TRANS/WP.29/920  
17 April 2003

World Forum for Harmonization of Vehicle Regulations (WP.29)

DRAFT SUPPLEMENT 4 TO REGULATION No. 107

(Double-deck large passenger vehicles)

"Figure 10

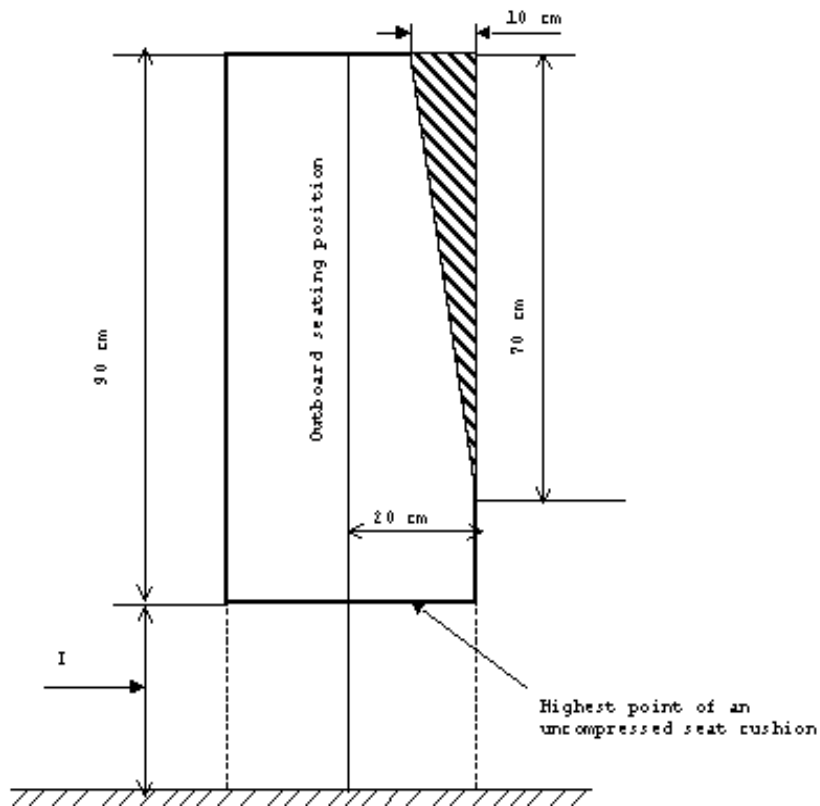
Paragraph 5.7.9.6.2.2., amend to read:

"5.7.9.6.2.2. Intrusion of a structural member provided that the intrusion is included within a triangle whose peak is situated 70 cm from the top and whose base is 10 cm in width and situated in the upper part of the space in question, adjacent to the side wall of the vehicle (see annex 3, figure 10);"

Annex 3, Figure 10, amend to read:
